DEVELOPMENT APPLICATION ASSESSMENT REPORT

Application Number:	DA2020/1173
----------------------------	-------------

Responsible Officer:	Phil Lane
Land to be developed (Address):	Lot 15A DP 31138, 14 Ernest Street BALGOWLAH HEIGHTS NSW 2093
Proposed Development:	Alterations and additions to an existing dwelling including landscape works and the construction of a swimming pool
Zoning:	Manly LEP2013 - Land zoned R2 Low Density Residential
Development Permissible:	Yes
Existing Use Rights:	No
Consent Authority:	Northern Beaches Council
Delegation Level:	DDP
Land and Environment Court Action:	No
Owner:	James William Barchard Martin Kathryn Ann Martin
Applicant:	James William Barchard Martin

3.4.1 Sunlight Access and Overshadowing

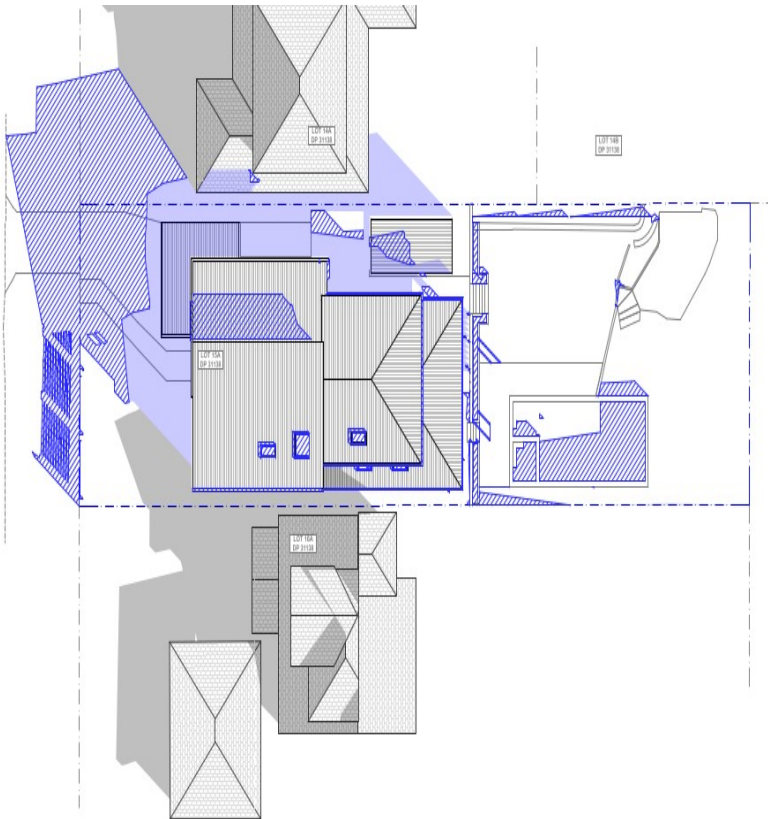
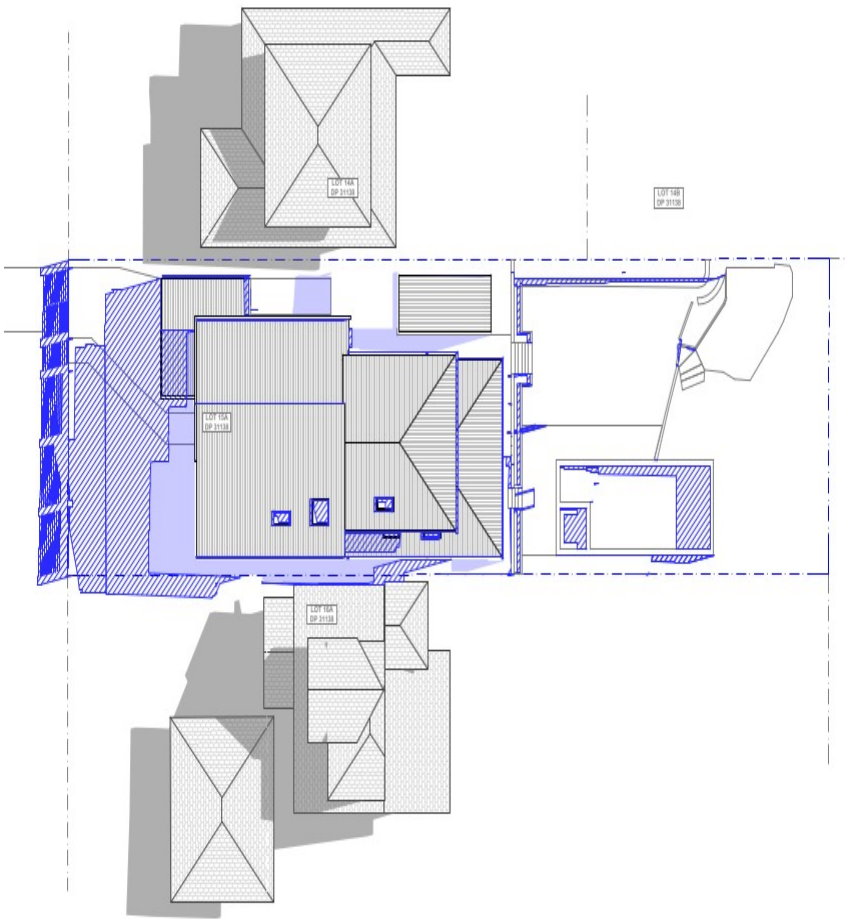
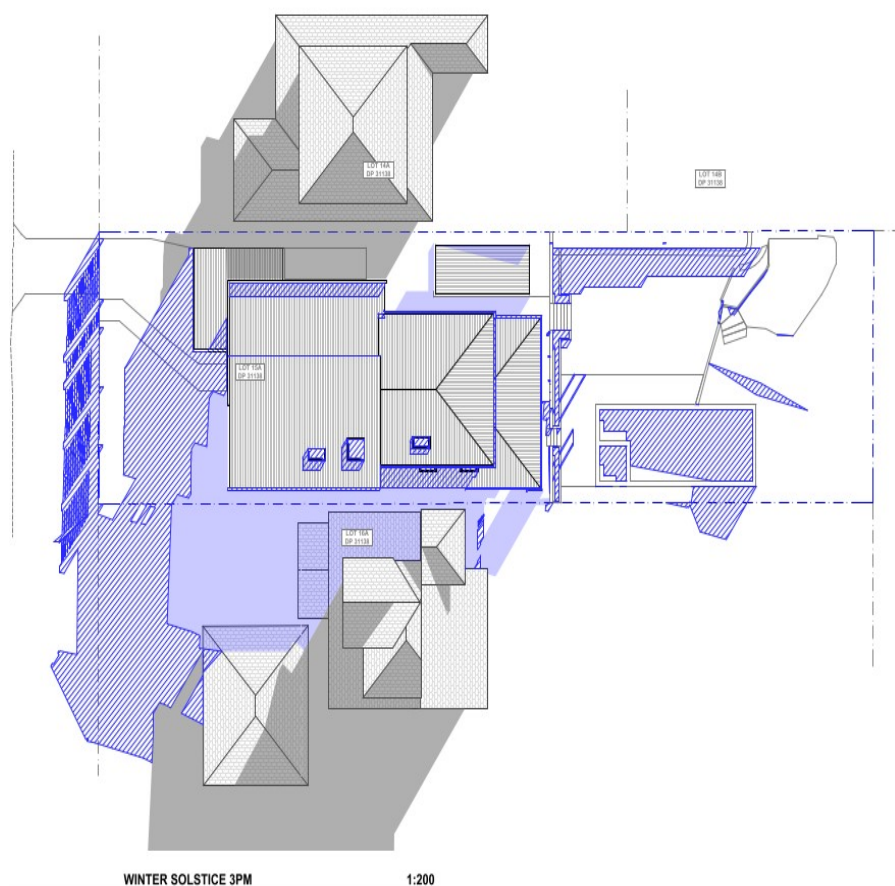
The proposed alterations and additions is considered to demonstrate sufficient solar access to the north facing living room at 12 Ernest Street.

Comment: As demonstrated by the submitted solar access diagrams the northern facing ground floor living room window will achieve this required. Additionally, the private open space will also achieve the required hours of solar access.

It is considered that the proposal is compliant with this clause and does not warrant refusal or further amendments via condition(s).
